2x10 FRAMING INSULATION ASSEMBLY

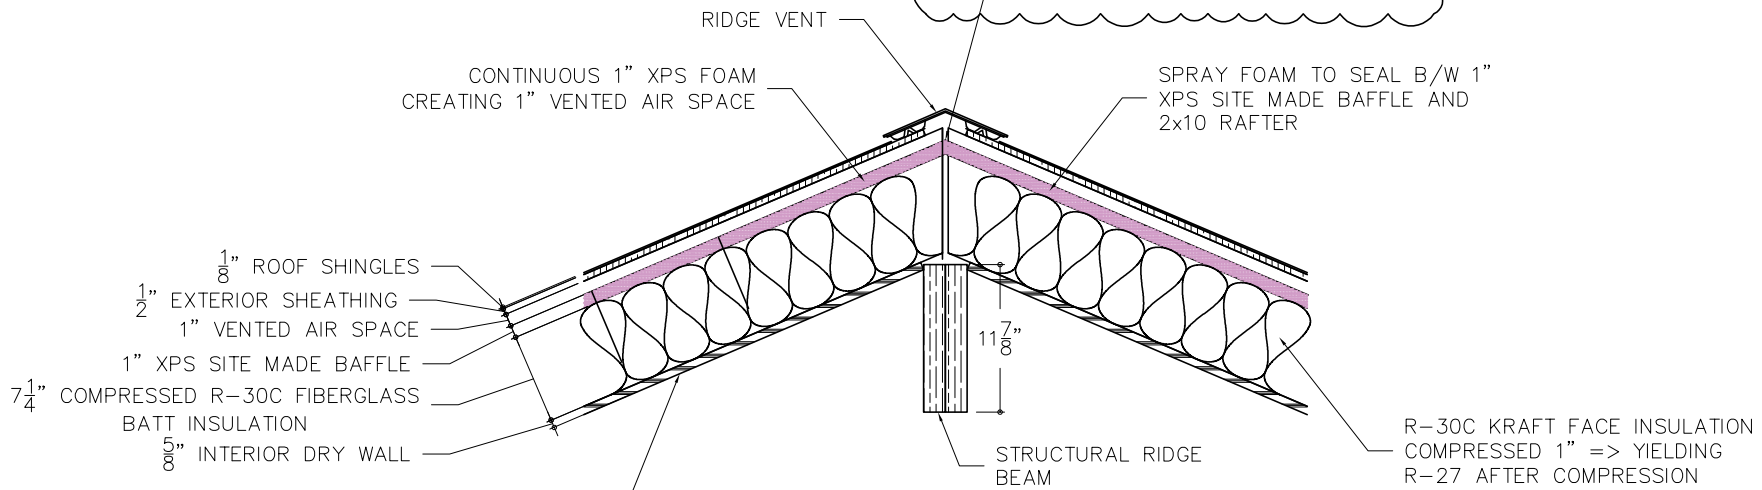
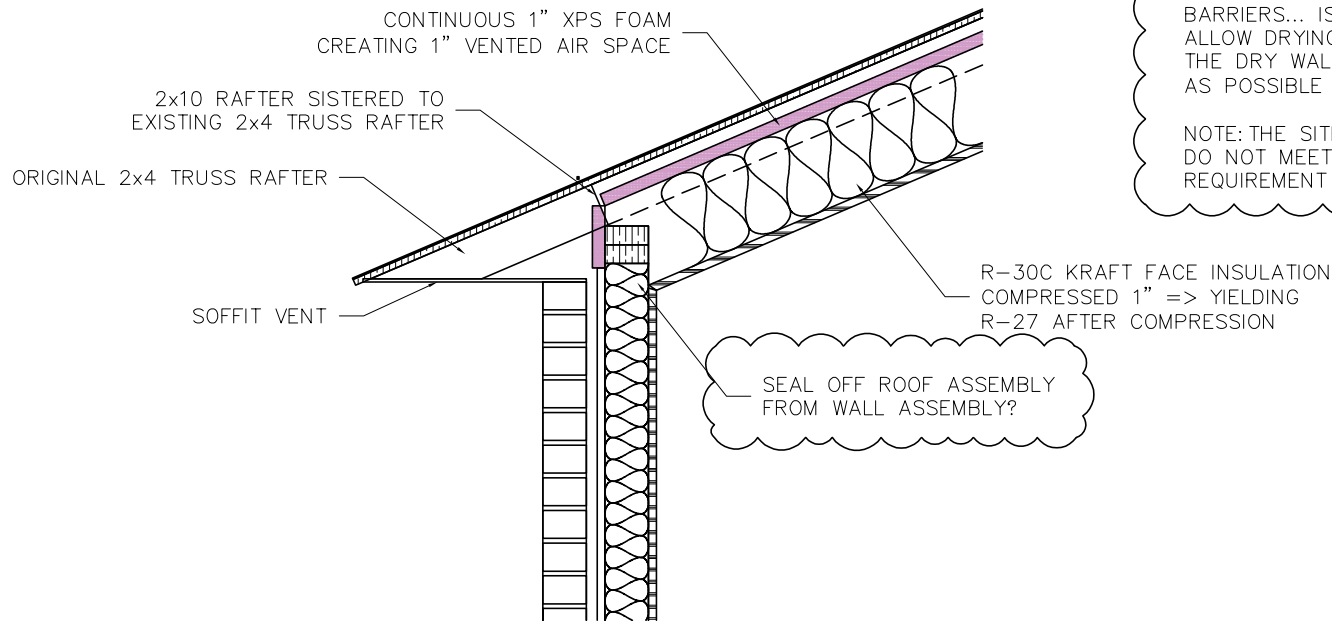
I AM ASSUMING THE SITE BUILT
BAFFLES ARE REQUIRED TO BE
CONTINUOUS FROM EAVE TO
EAVE?

IS REGULAR LATEX PAINT OVER
GYPSUM BOARD OK?

IS THE KRAFT FACED CONSIDERED A TRUE
"SMART" VAPOR BARRIER? SHOULD I GO
UNFACED?

THIS ASSEMBLY IS SANDWICHING THE
FIBERGLASS INSULATION BETWEEN TWO VAPOR
BARRIERS... IS THIS OK? WILL KRAFT PAPER
ALLOW DRYING OF ANY POSSIBLE VAPOR ENTRY?
THE DRY WALL WILL BE INSTALLED AS AIR TIGHT
AS POSSIBLE W/ NO CAN LIGHTS, ETC.

NOTE: THE SITE MADE XPS INSULATION Baffles
DO NOT MEET THE 20% INSULATION
REQUIREMENT FOR AN INWARD DRYING ROOF.

SEAL OFF ROOF ASSEMBLY
FROM WALL ASSEMBLY?
